February 19, 2020
(Revised April 13, 2021)
Project No. 109052001

Subject: Responses to Cycle Issues
Federal Boulevard Dechannelization and Trail Project
San Diego, California
City of San Diego Project Number 612886

References: City of San Diego, 2021, Cycle Issues, 2 LDR-Geology, Project Number 669559:
dated January 19.

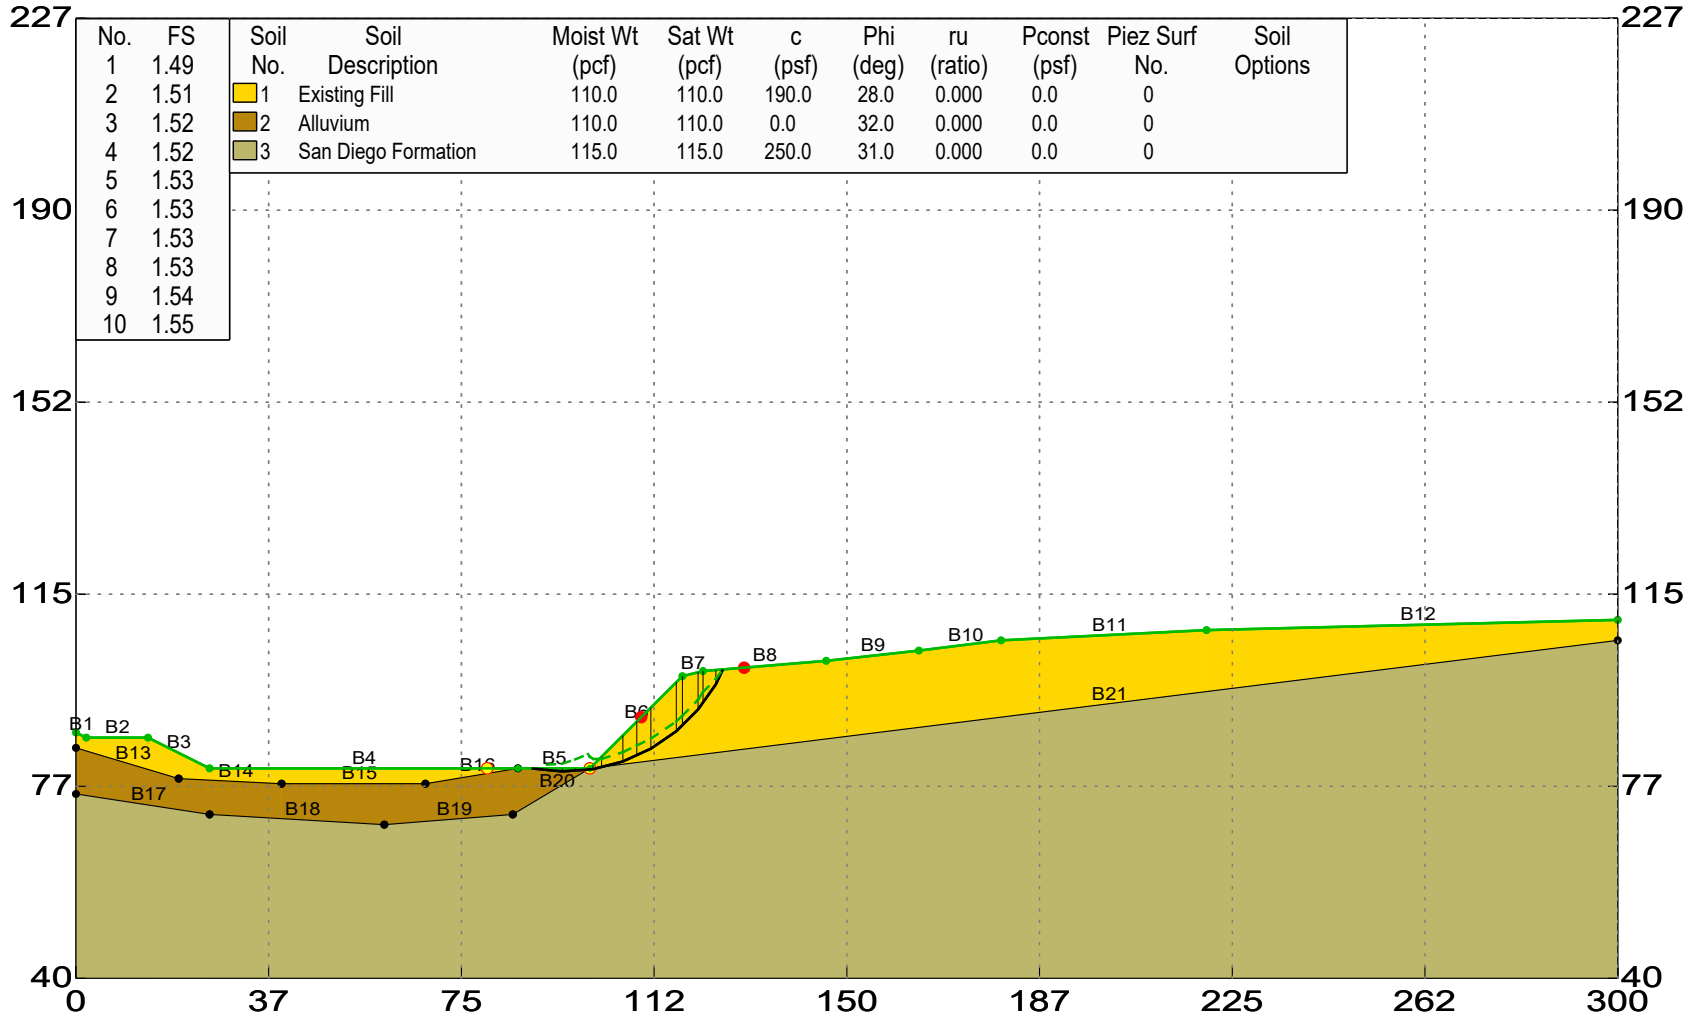
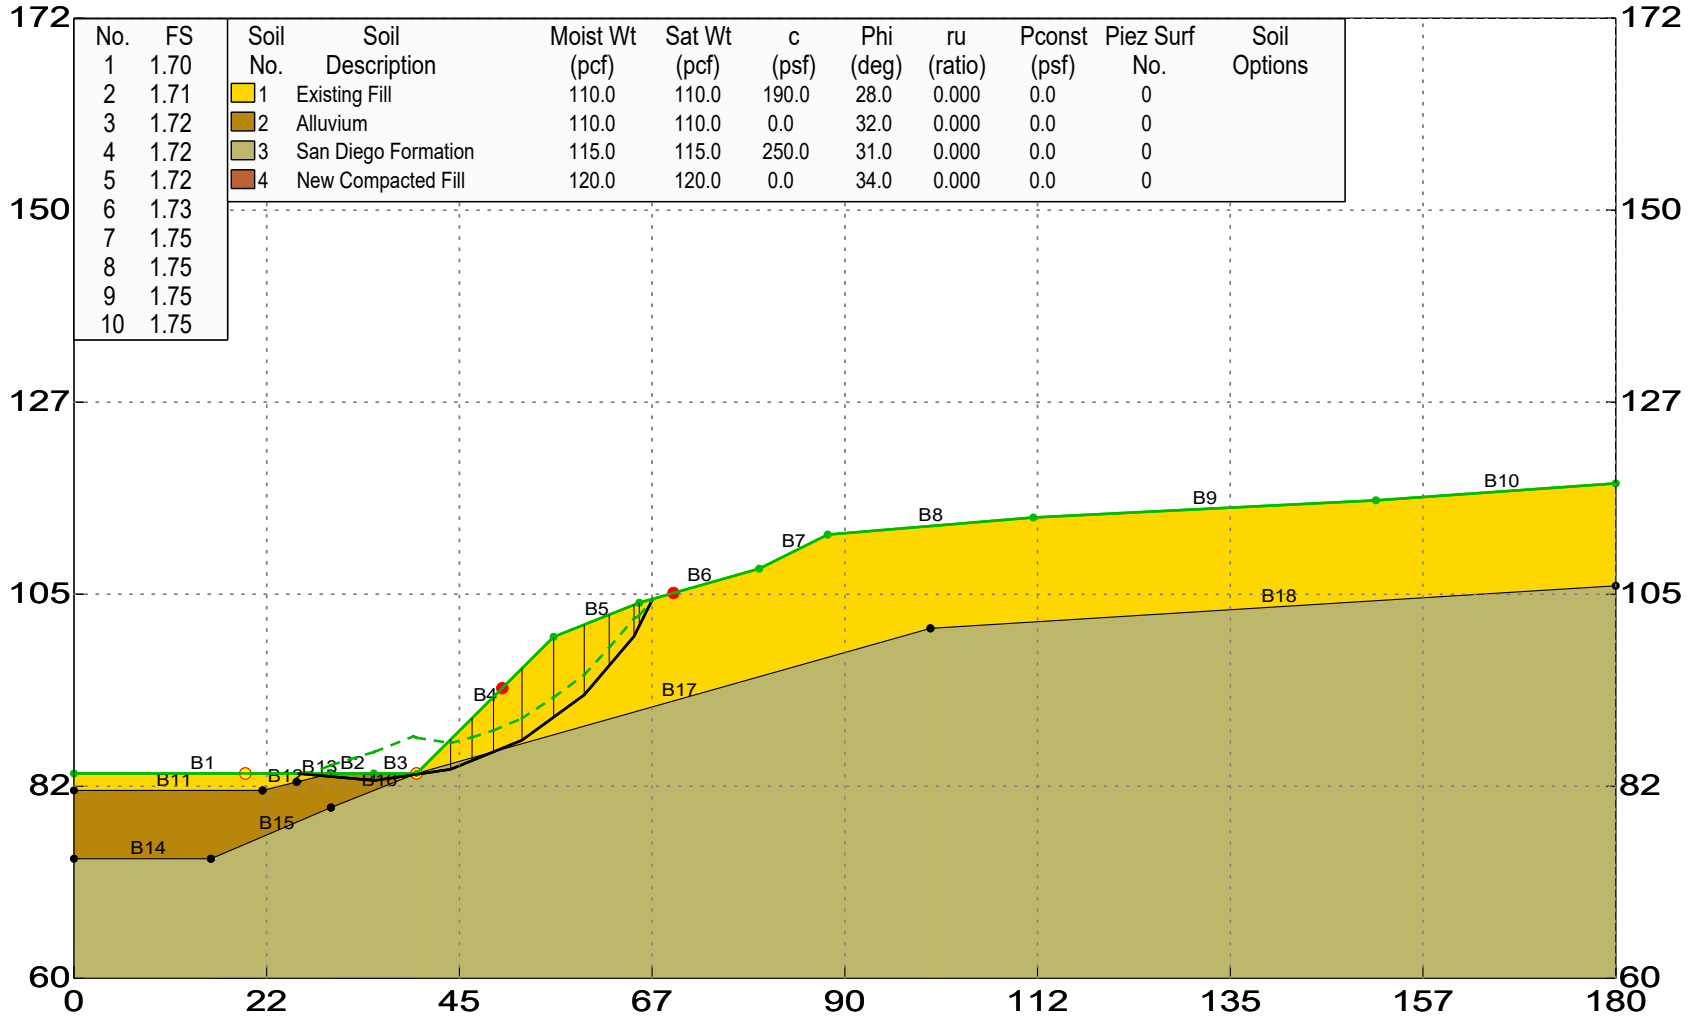
Remaining Review Issues - Issue Number 19: *The referenced report does not appear to use a saturation depth of 5-feet in the slope stability analysis. Per the City's Guidelines for Geotechnical Reports, if the depth of saturation used in the surficial slope stability analysis is less than 5-feet, the shallower depth must be justified. The project's geotechnical consultant should justify the depth used in their analysis or provide revised slope stability analysis.*

Response: Section 10.1.7 of the referenced report (Ninyo & Moore, 2020) recommends that finished slopes be constructed at inclinations of 2:1 (horizontal to vertical) or flatter. Per the City of San Diego's 2018 Guidelines for Geotechnical Reports, indicates that the surficial slope stability analysis is required for slopes steeper than 2:1.

Note, the slope stability analyses presented in Appendix D of the referenced report (Ninyo & Moore, 2020) for slopes steeper than 2:1 are for the temporary construction slopes, not finished slopes.
